A66 Northern Trans-Pennine project

Proposed changes consultation

January/February 2023

DC-01 – Change in speed limit west of M6 Junction 40

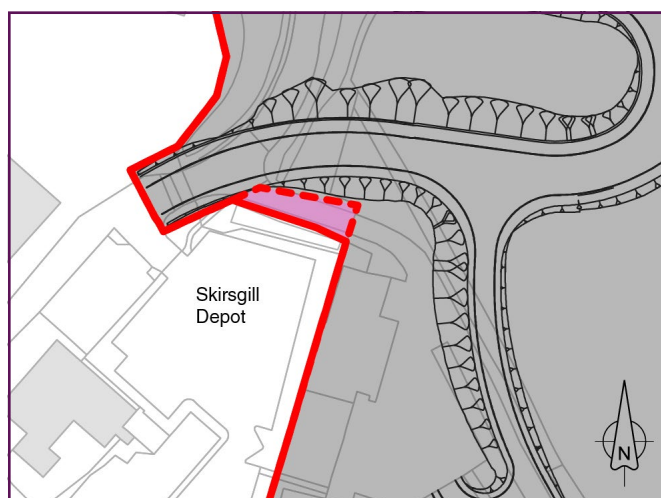
Our proposed change would reduce the speed limit from 70mph to 30mph on both the eastbound and westbound carriageways of the A66, between the railway bridge and Junction 40. As a result, there could be no need to add merge and diverge lanes to the auction site access. A more compact junction arrangement (similar to the existing access) would be safe and suitable.

This change would make the shared cycleway safer and reduce the speed of eastbound traffic passing the entrance/exit to the auction site as it approaches the roundabout at Junction 40 of the M6. The more compact arrangement for access to the auction site would be more in keeping with the existing access and would reduce our impact on the landowner and the auction business by reducing the land required.

This design change would help to reduce the area of carriageway/hard standing required. This could shorten the construction programme, simplify the drainage and signage arrangements and reduce the amount of materials needed for construction.

DC-02 – Realignment of walking and cycling route at Skirsgill

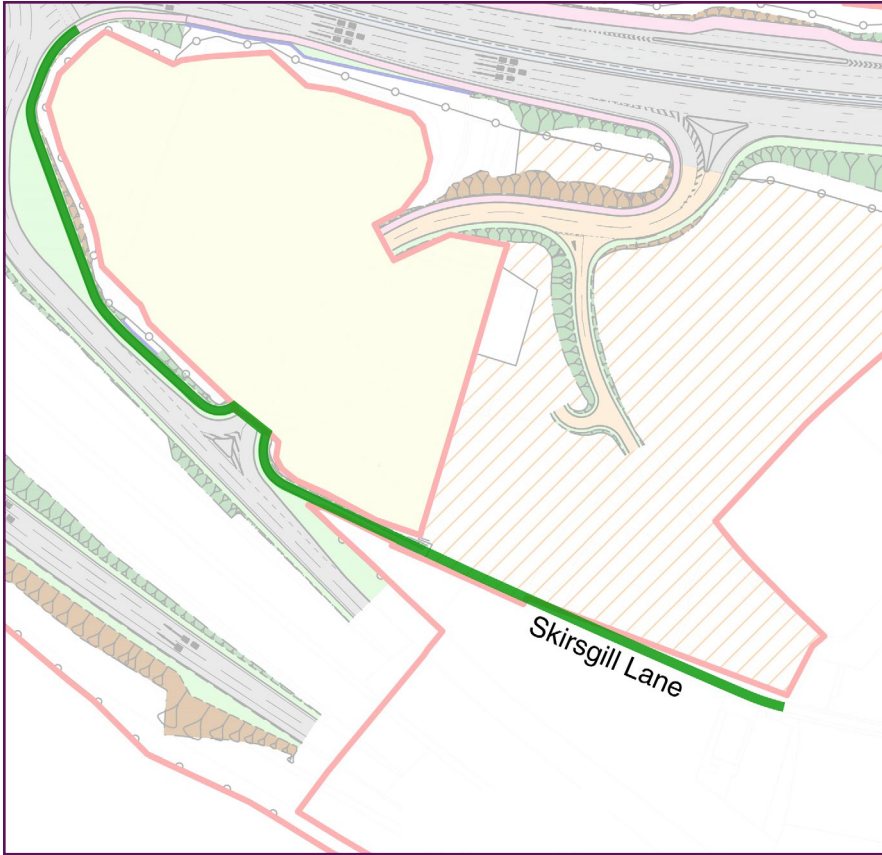
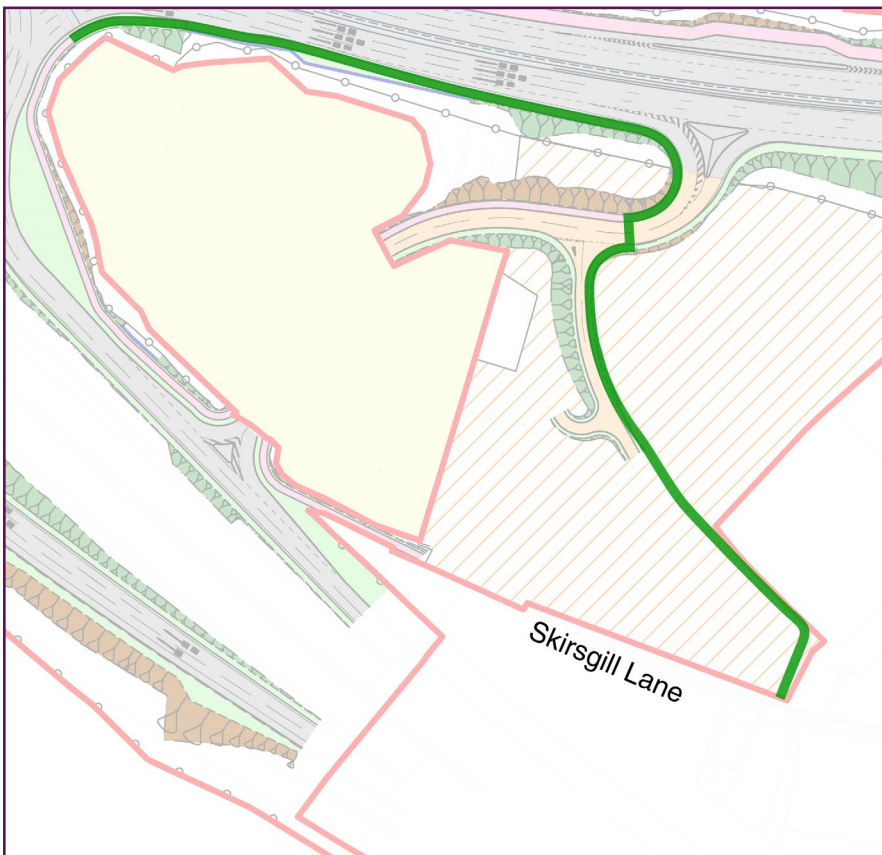
This change proposes that we divert the footpath from the slip road and re-direct it alongside the boundary of the Skirsgill depot to the north. Pedestrians and cyclists will take a route which runs adjacent to the A66 before heading south east to join Skirsgill Lane.

The proposed route is a more attractive and safer alternative for walkers and cyclists who would be redirected away from the M6 Junction 40 southbound slip road.

This would require a small change to the Order Limits for our DCO application.

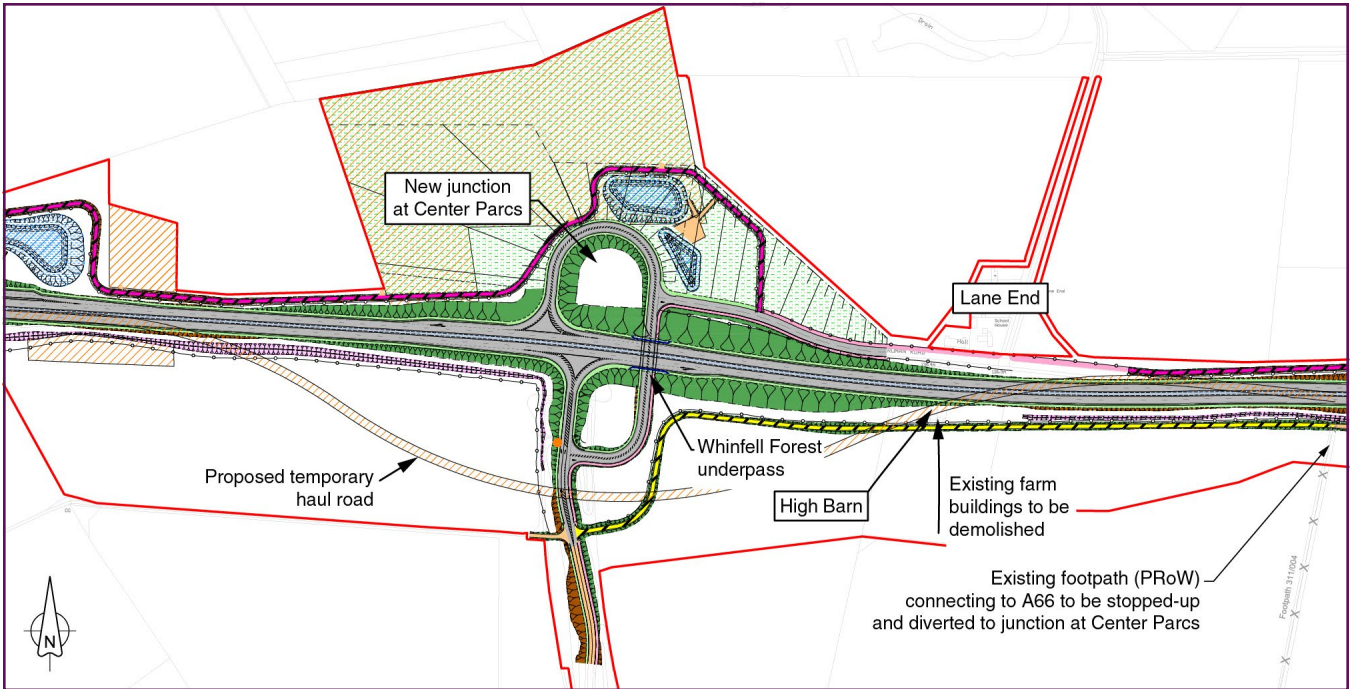
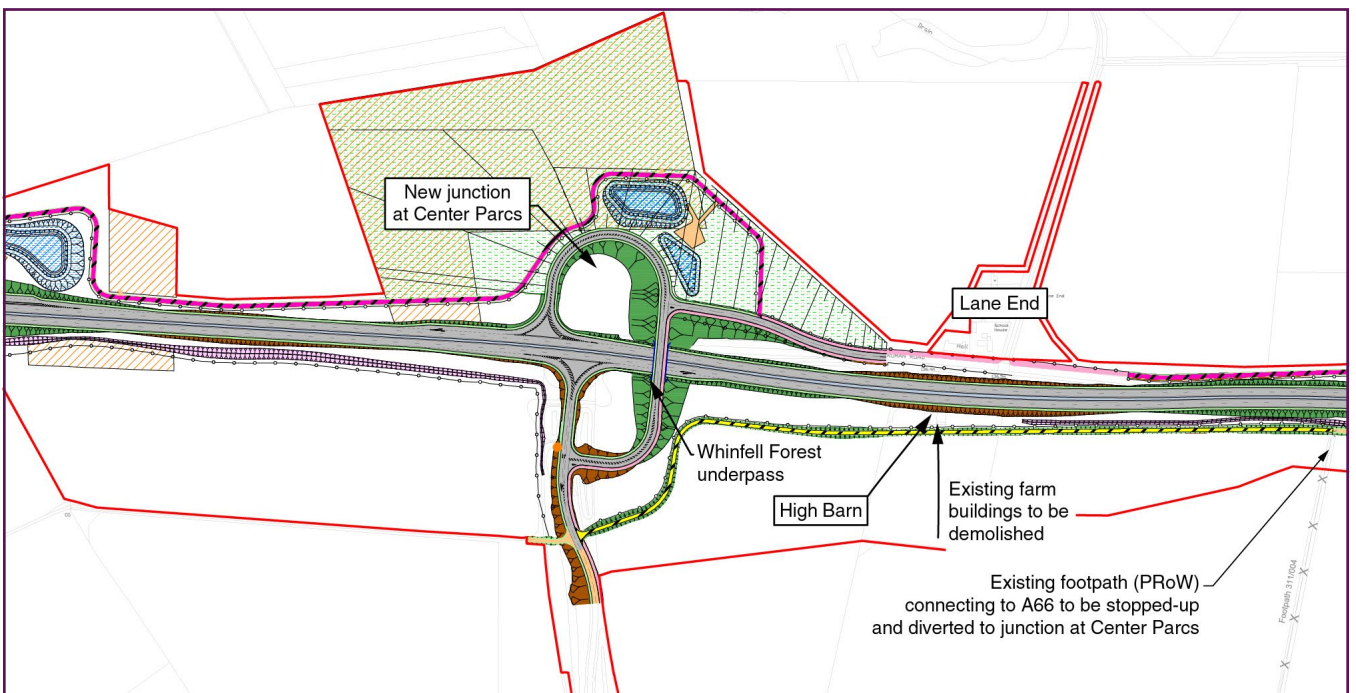
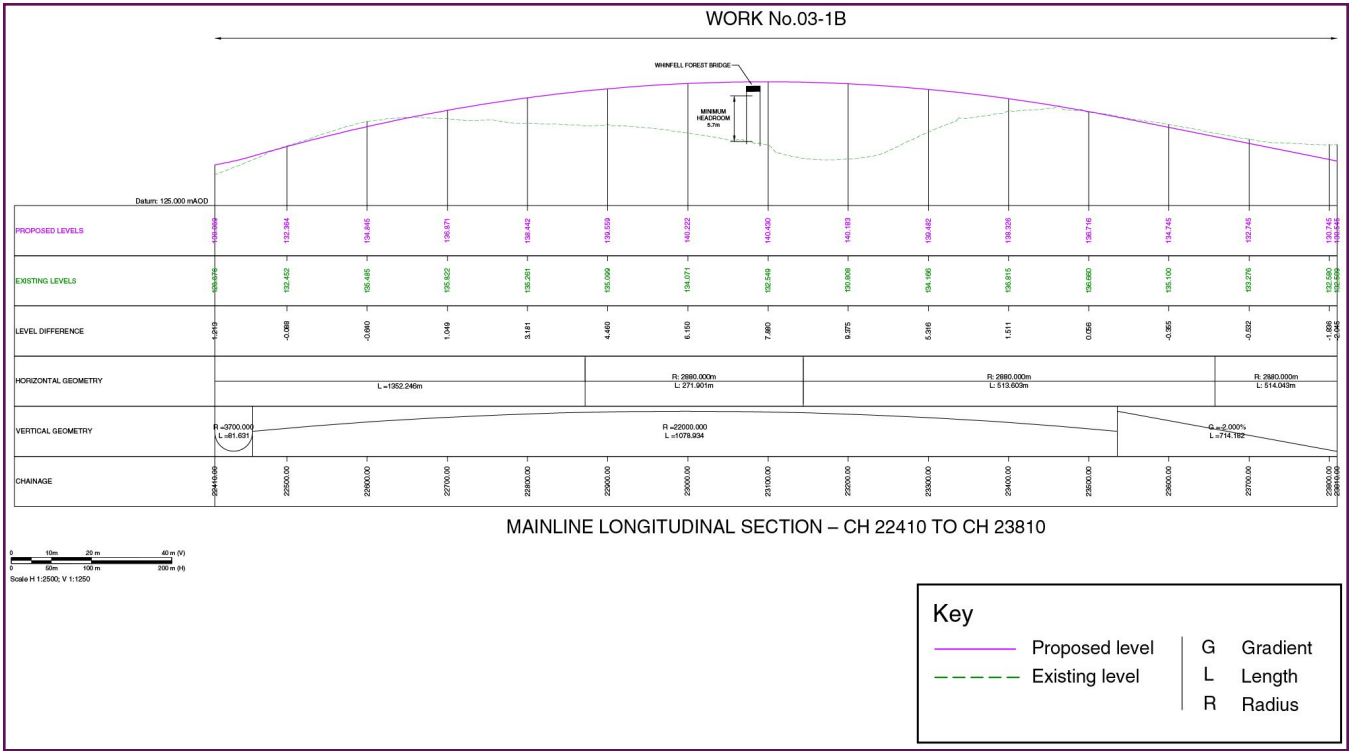
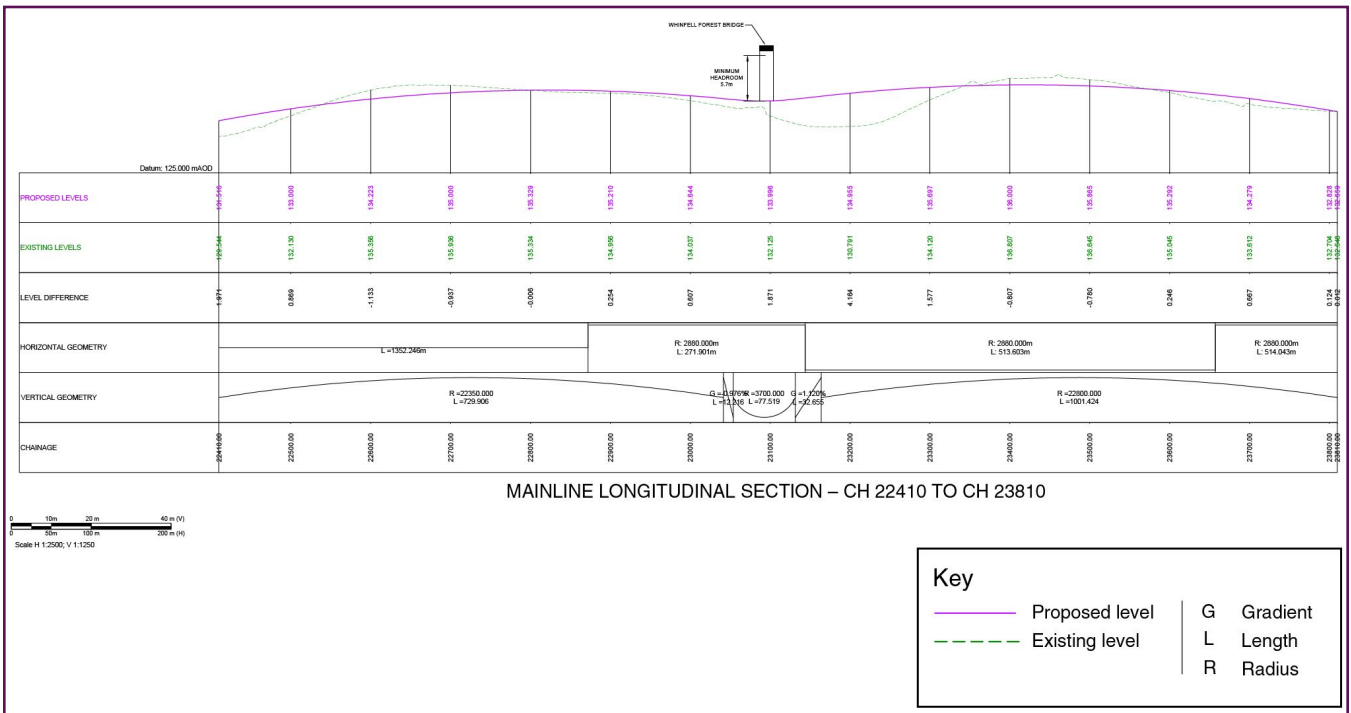
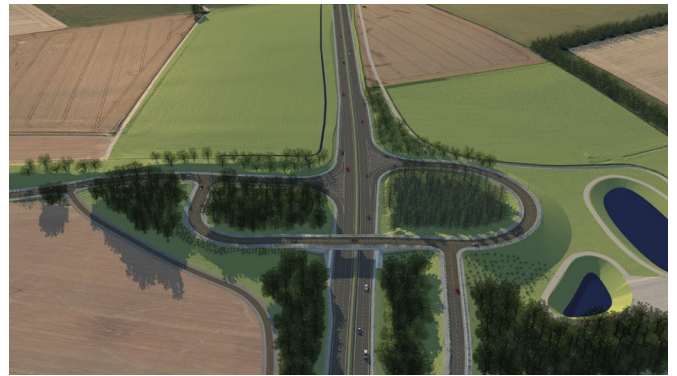
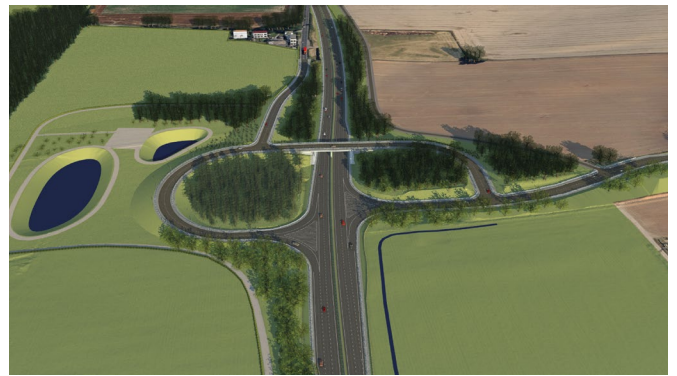
We are now proposing to invert this junction so that the mainline of the A66 would more closely follow the existing road at ground level rather than being elevated on an eight-metre-high embankment. The local road access, which forms part of the junction, would cross over the A66 mainline on a bridge rather than passing underneath it. The proposed bridge would be at a similar height to the embankments included in the DCO design.

The proposed change removes the need for the temporary diversion, which would have been around 1.2km, minimising disruption for road users. The new bridge would be built in two sections with traffic initially being retained on the existing A66 while the westbound carriageway and southern half of the structure is constructed. Once complete, traffic will be switched to the newly-built carriageway whilst the northern half of the structure and eastbound carriageways works are completed. This will substantially reduce the construction period and amount of temporary work in this location as well as reducing construction traffic.

This would also remove the need for large earthworks which, due to soil disturbance, would impact on the productivity of the surrounding land for some time to come and would require a high number of vehicles to transport material. It would also reduce the overall land required for the project.

Another key consideration of this proposal is the potential change in the visual impact for properties on the northern side of the A66 to the east of the junction.

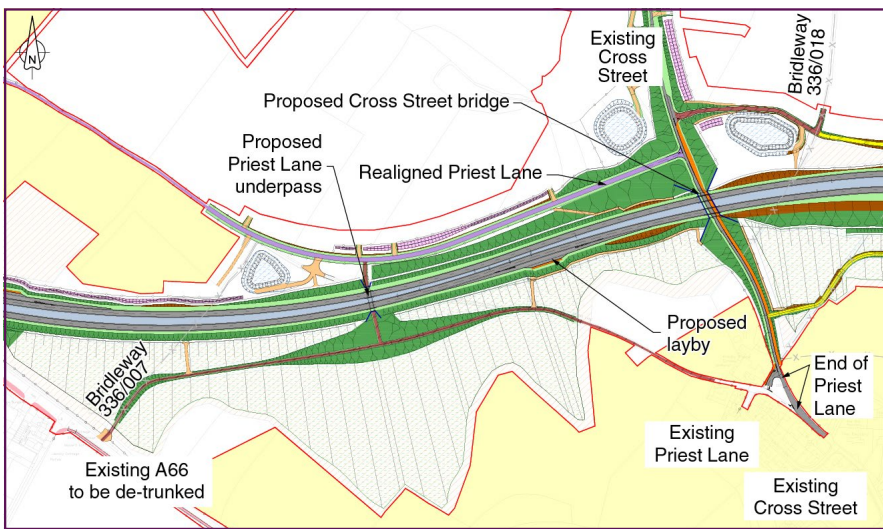
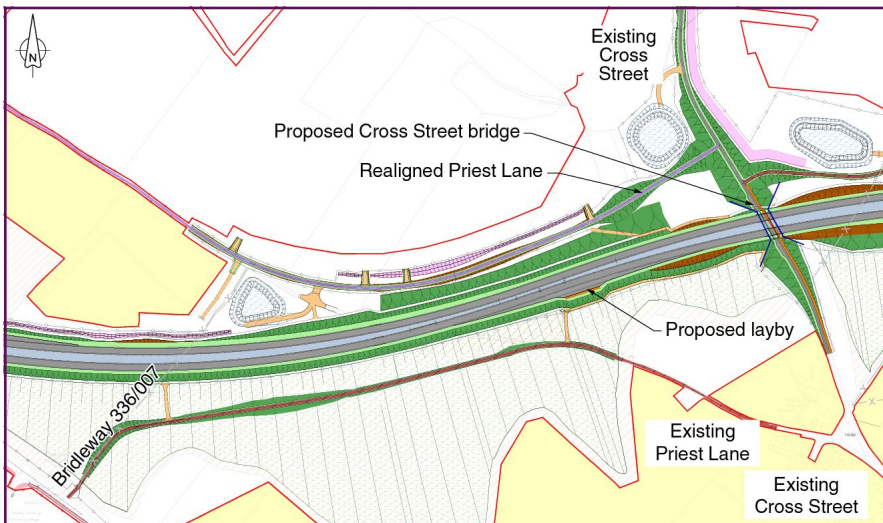
We propose to no longer provide the Priest Lane underpass and redirect both WCH and the landowners requiring access to their farmland via Cross Street.

Our proposal to remove the underpass enables the shared bridleway to be raised closer to existing ground levels, meaning landowners would retain more land for farm use as the size of the earthworks required for the bridleway will be reduced.

As a result of early detailed design it was determined that the underpass would require lighting. By removing the underpass we remove any potential impacts of the lighting in a rural area whilst there would be a reduction in construction works associated with electrical supply to the underpass.

Proposed change (inset shows walking route between Cross Lane and Fell Lane)

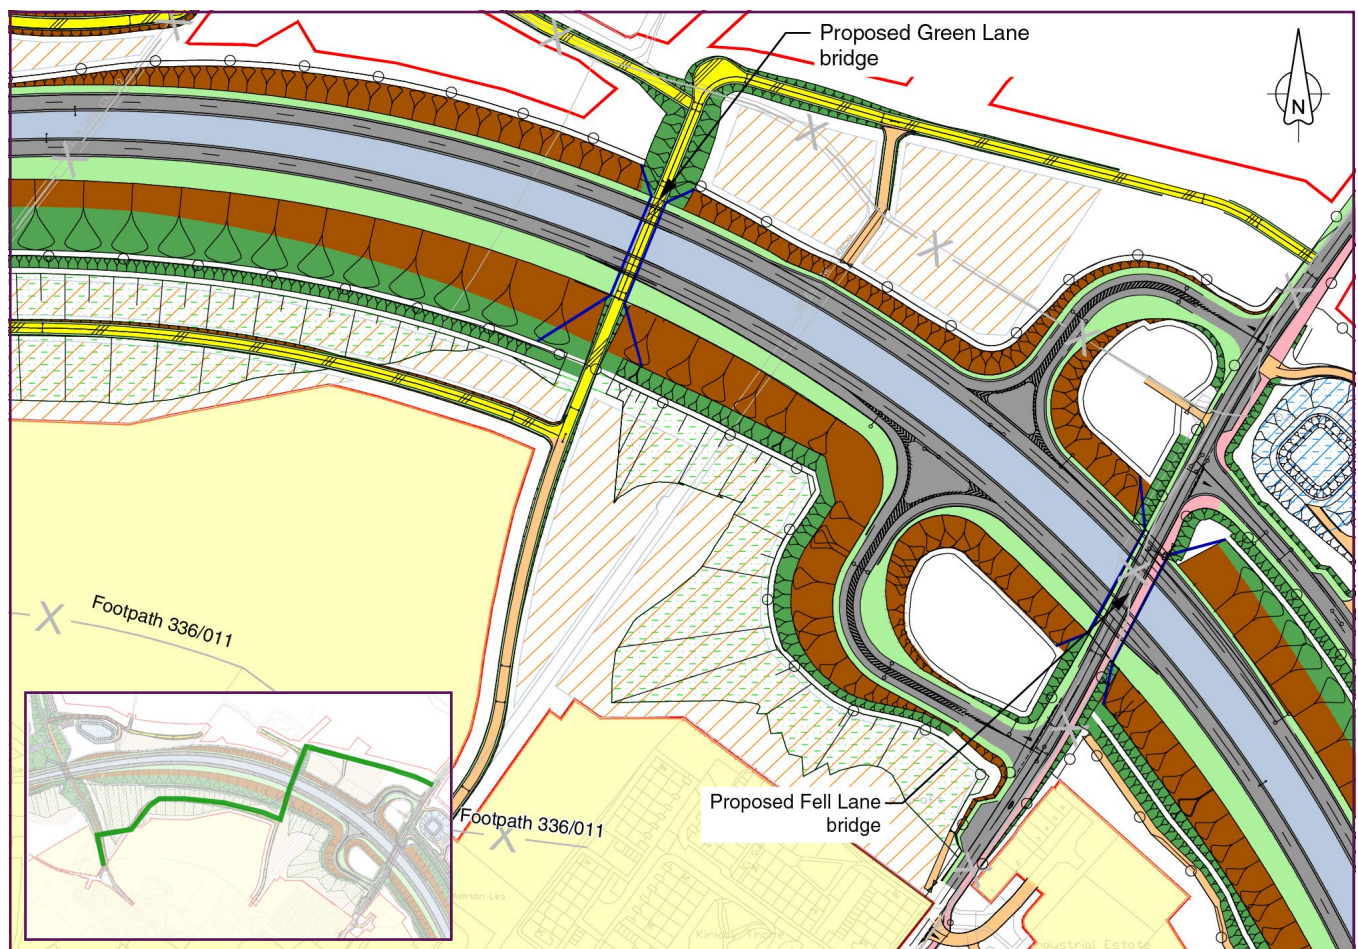
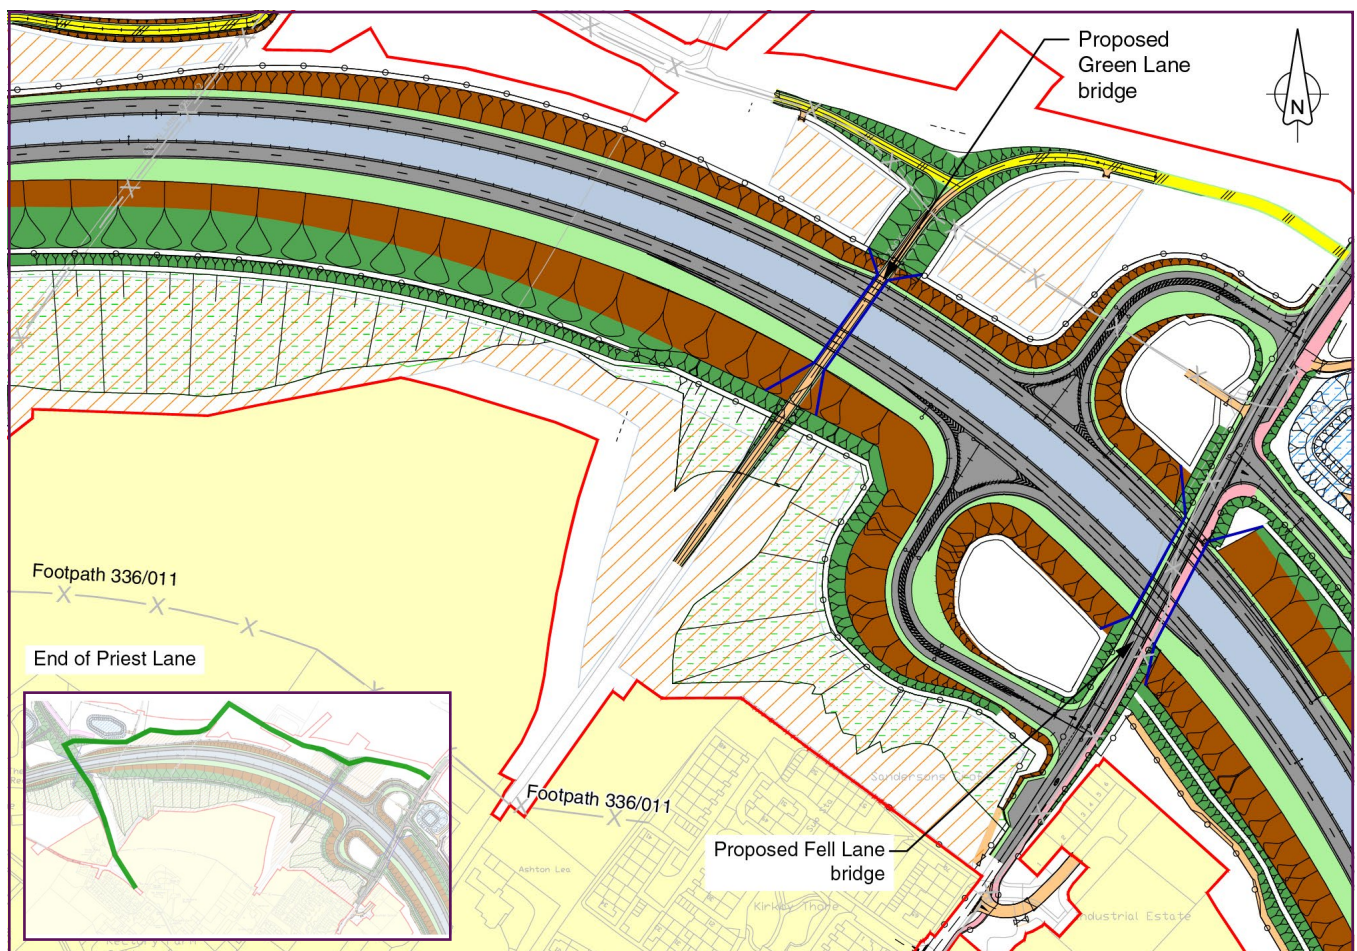
The change we are proposing is to make Green Lane bridge a private access track, meaning only the landowner will use it. Walkers, cyclists and horse riders (WCH) will be able to use Cross Street or Fell Lane to reconnect to the

We are also proposing to move the bridge back to the original alignment of the current farm access track rather than the current designed location which cuts diagonally across the field. This change has been discussed with the landowner who is in agreement with the proposed change.

This change means the width of the bridge would be reduced as it now serves only one purpose.

Reducing the width of the bridge would reduce the scale of the structure and therefore the length of the construction period. This change also reduces the land required for the project.
